**ADVERTISEMENT FOR BIDDERS**  
**for**  
**OLD BALLGROUND SANITARY SEWER REPLACEMENT PHASE 2 AND**  
**ETOWAH RIVER TRAIL EXTENSION**

**AUGUST 28, 2020**

**ADDENDUM NO. 2**

**STEEL CASING / PIPE SUPPORT INSTALLATION**  
NTS

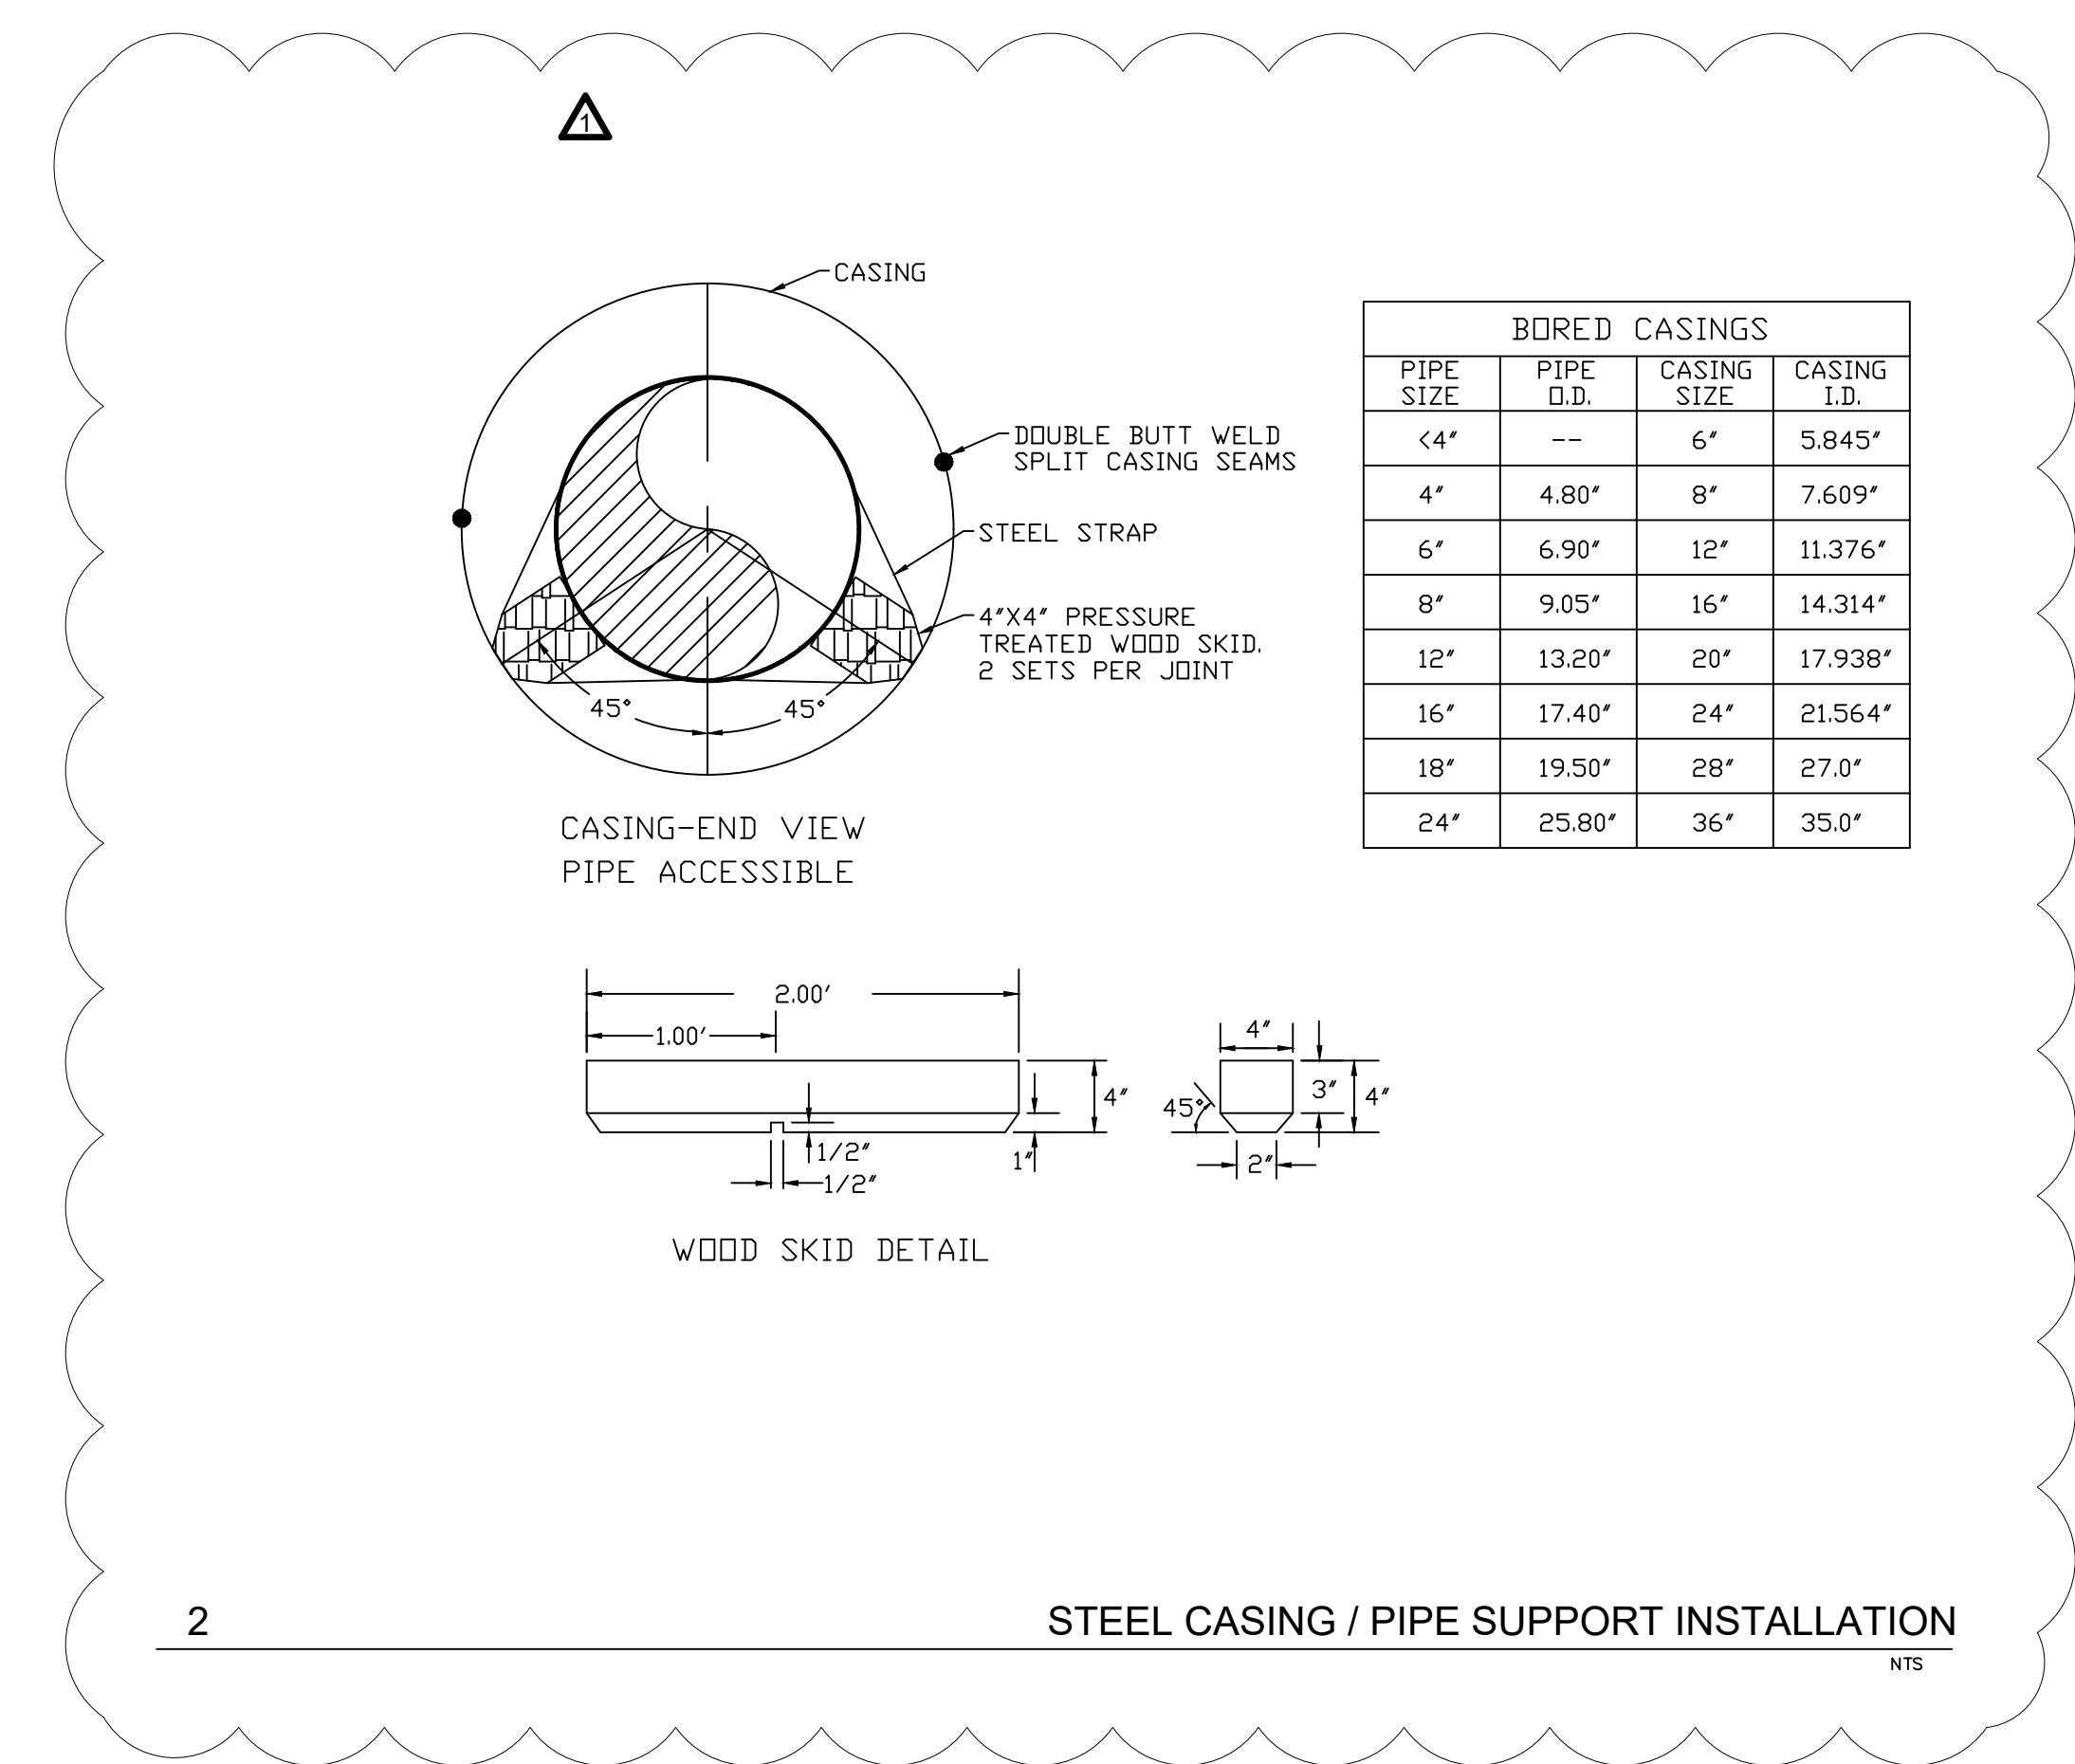
43. Are any 2" PVC GPS Data Collection Pipes required? **Yes for all water mains.**
44. Bid Item 149 – 30" Steel Casing is shown being installed on EXISTING 24" Sanitary. Is this the intent? What is the detail for installation? **Yes. Steel Casing is to be installed around Existing 24" Sanitary Sewer Pipe. Steel Casing has been revised to 36" size (See Bid Item 160) and construction detail for casing is located on Sheet 40-04 (Detail 2).**

JOB NUMBER: 2020-1435
DATE: 08/10/2020
DESIGNED BY: KAS
DRAWN BY: KAS
CHECKED BY: JVP
SHEET NO. <b>PT02</b>

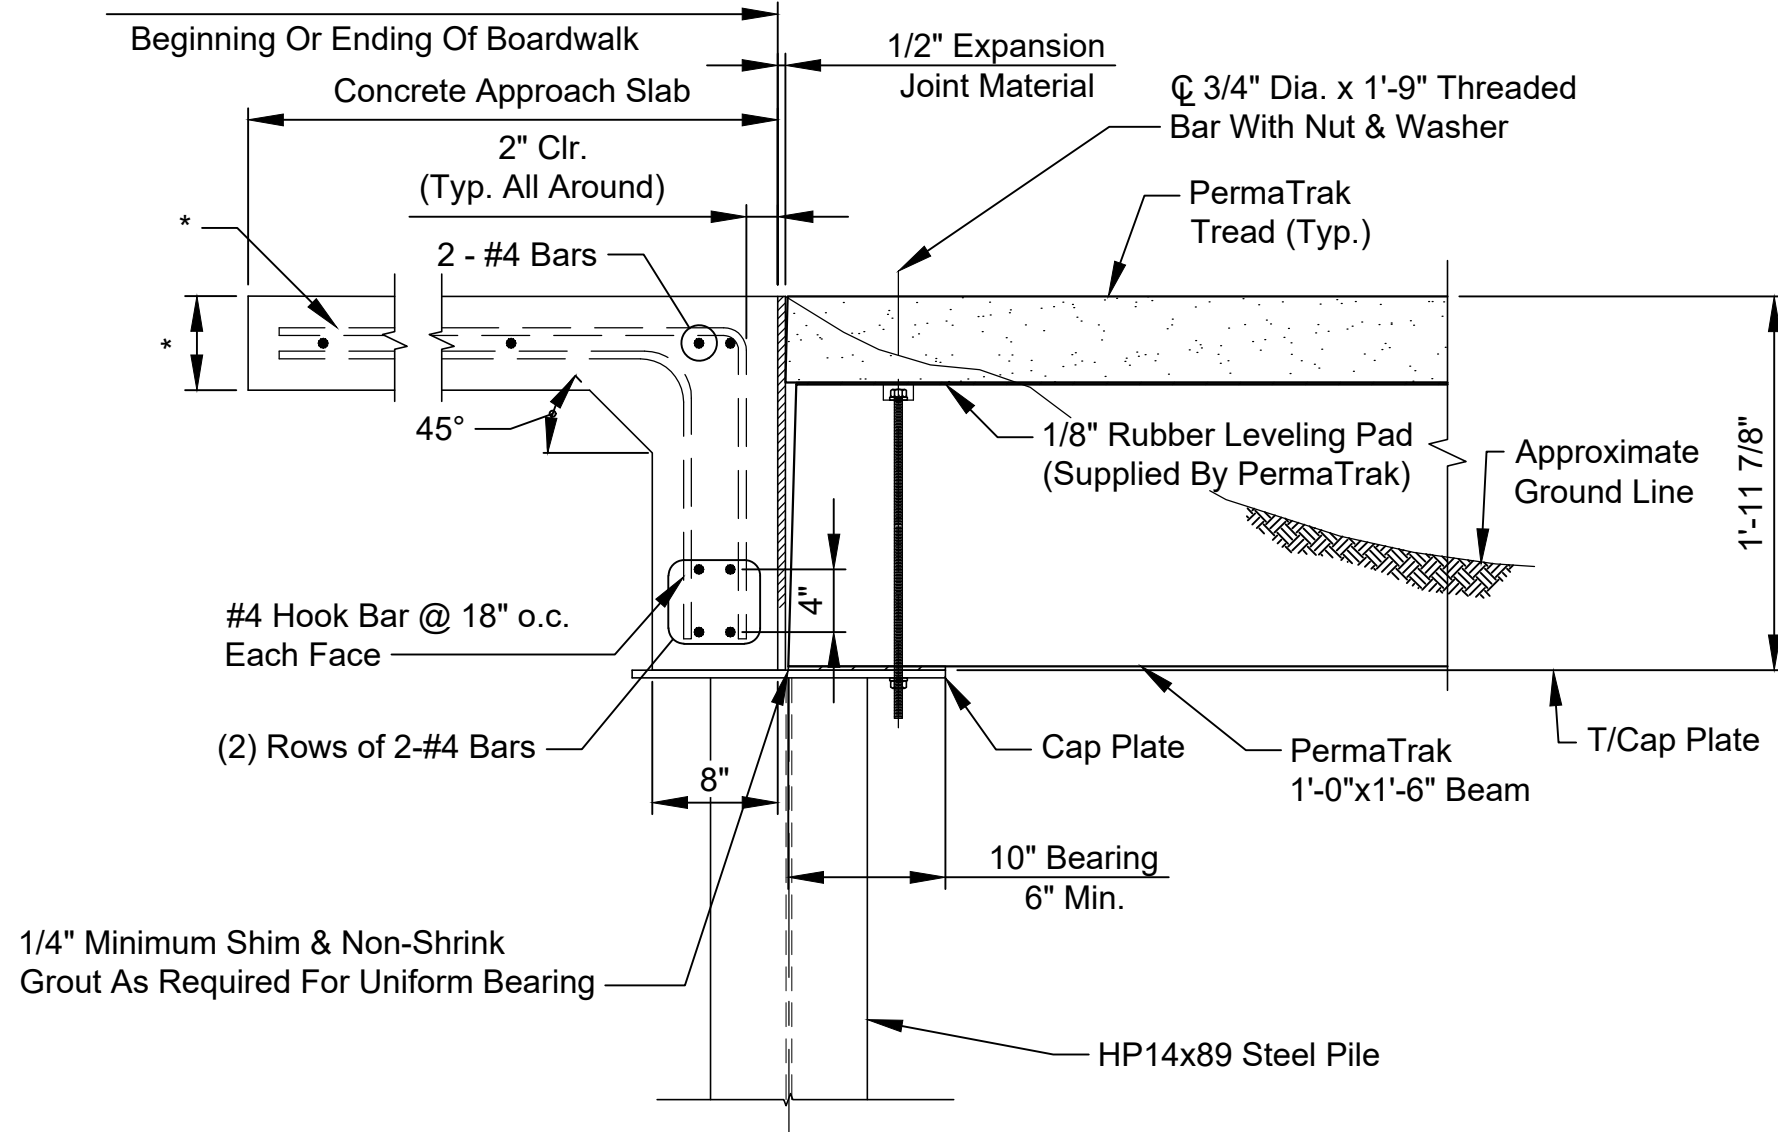
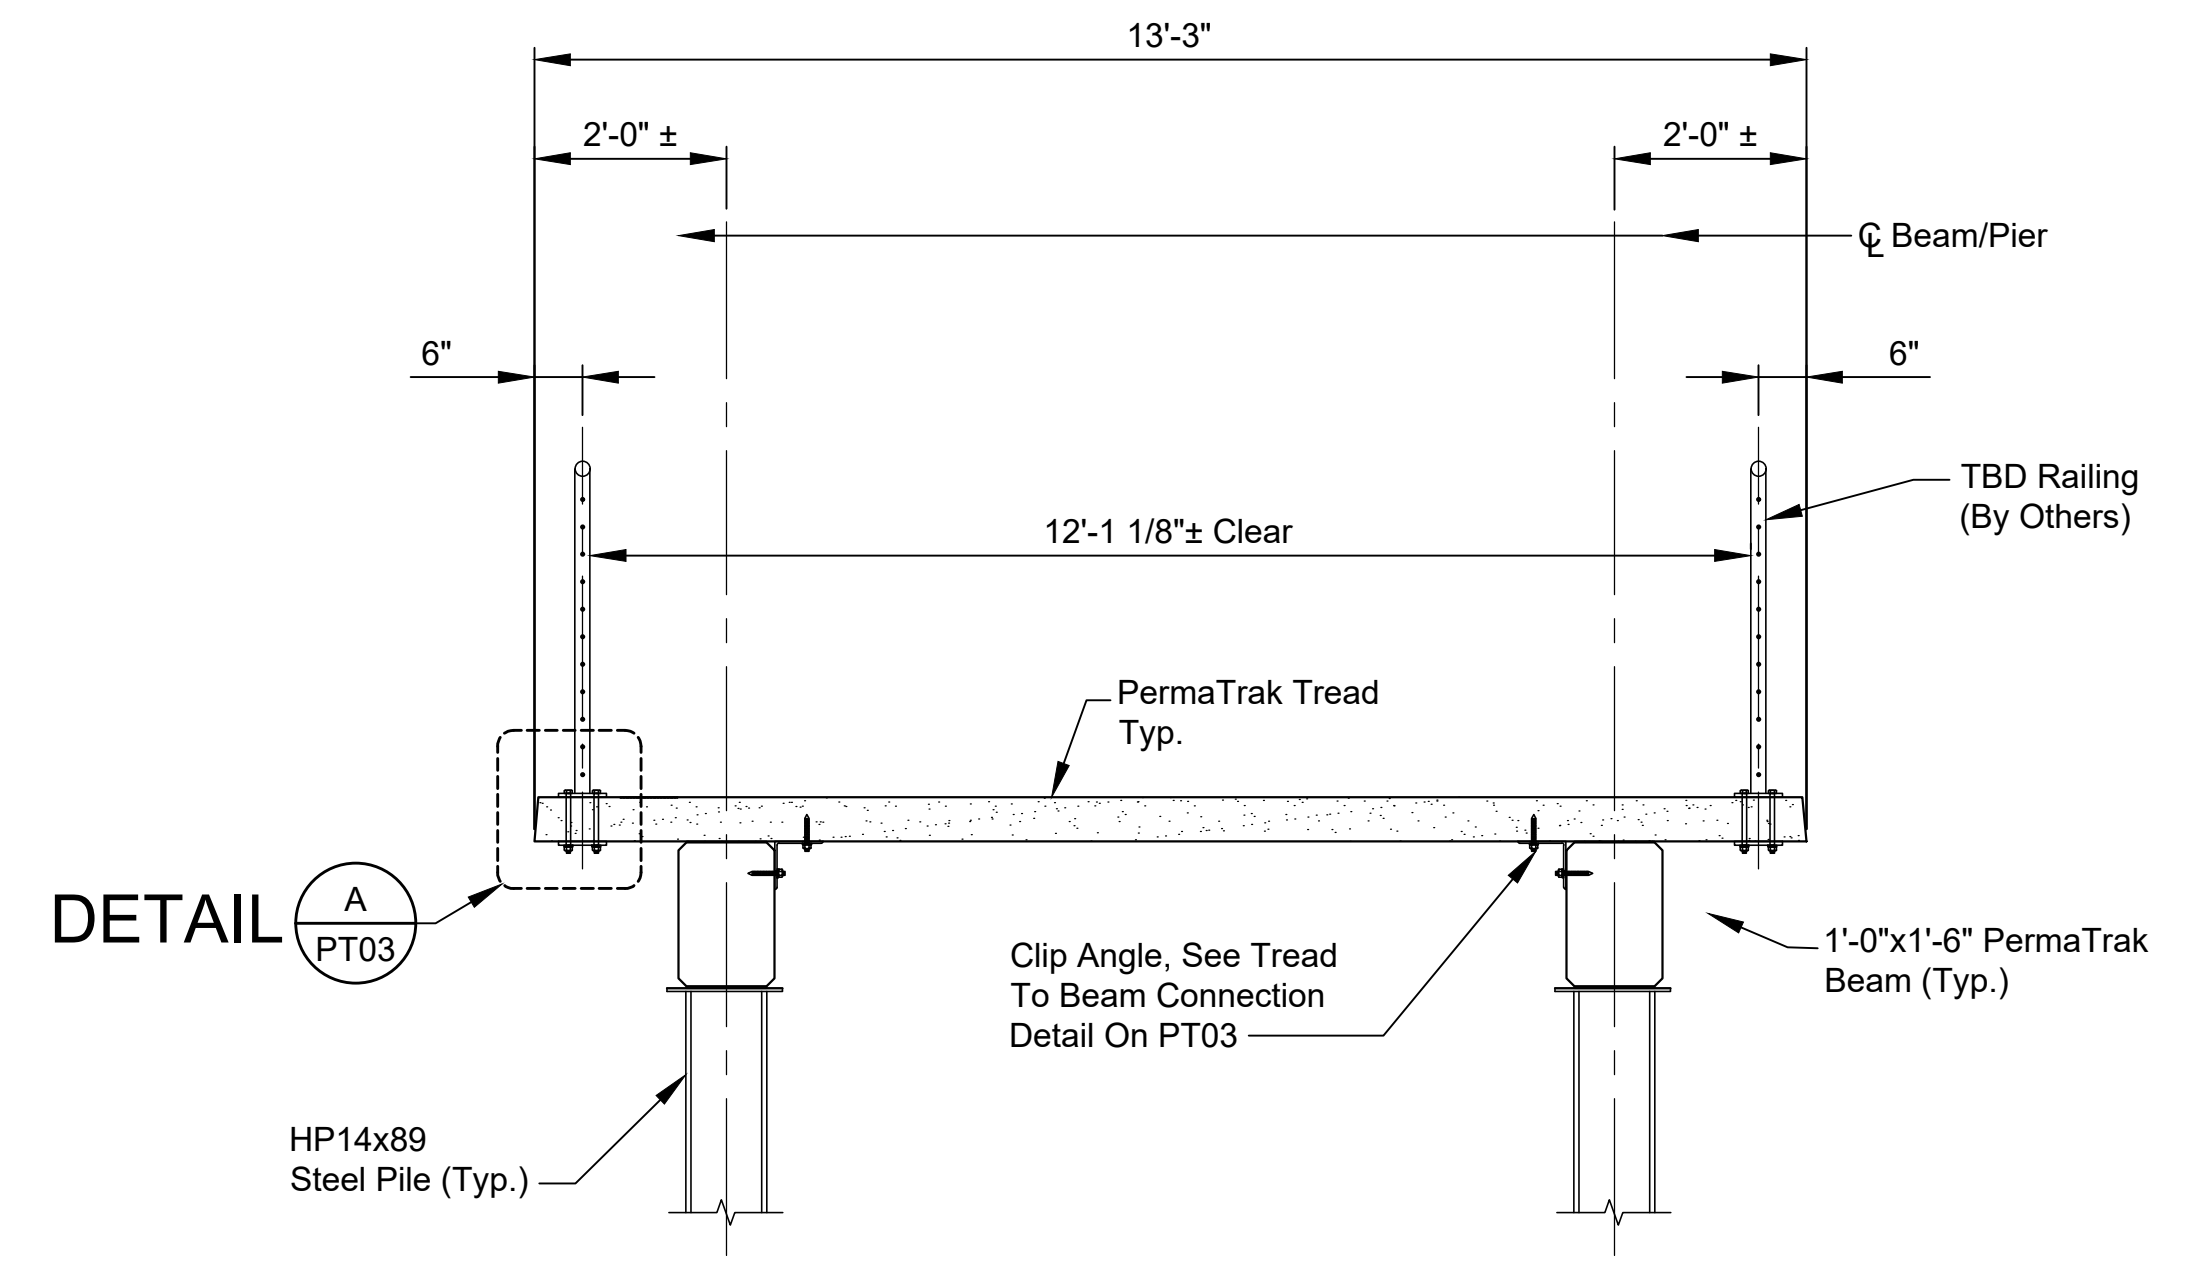
75. Reference PermaTrak Drawing PT-02:
- a. Typical Section 1’-0” x 1’-6” beams. Please provide connection details to the HP 14 x 89 steel piles. **Contractor shall refer to PermaTrak Sheet PT-03.**
